RESPONSE TO AUDIT ISSUES

APR1400 Topical Reports

Docket No. PROJ0782

Review Section	TR Realistic Evaluation Methodology for LBLOCA of the APR1400
Application Section	Topical Report: APR1400-F-A-TR-12004 Realistic Evaluation Methodology for Large-Break LOCA of the APR1400
Issue Date	08/13/2015

Figure 1. Figure 4.4-1 of the reference [1]

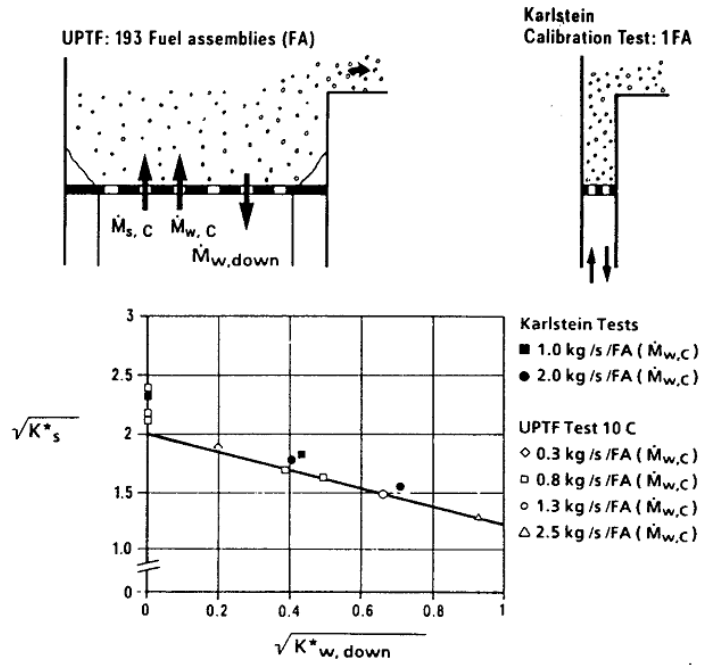
The guidance in RG 1.157, Section 3.11 establishes acceptable controls regarding the calculation of core flow distribution. Section 4.2.2.1.2 of the topical report states that the uncertainty in the high importance phenomenon of []^{TS} is not determined because it is included in the steam binding bias. Flow through the top nozzles is a complex multidimensional process with liquid down flow through the lower power outer assemblies and steam and entrained liquid up flow through the central higher power assemblies. Bias in the steam binding process is not directly related to the uncertainty in the countercurrent flow at the top nozzles. Demonstrate how the bias in the steam binding process bounds the uncertainty in countercurrent flow at the top nozzles or provide the bases for neglecting the relevant uncertainty.

Returning to the CCFL phenomena, CCFL on tie plate is very complicated hydraulic phenomena. As shown in Figure 1, CCFL phenomena consist of three flow streams, the steam and water up-flow from the core and the water fallback. RELAP5 has two fluid flow fields. Therefore, it is not easy to correctly model the CCFL phenomena with RELAP5. RELAP5 treats CCFL with a general model that allows the user to select the Wallis form, the Kutateladze form, or a form in between the Wallis and Kutateladze forms[2].

In general, experiments on CCFL are well correlated with the Kutateladze number as shown in Figure 1. Most important thing to check is the limiting gas velocity, $v_{s,Limit}$, above which no down-flow is possible.

$$K_{s,Limit}^* = 4.0, \text{ From Figure 1}$$
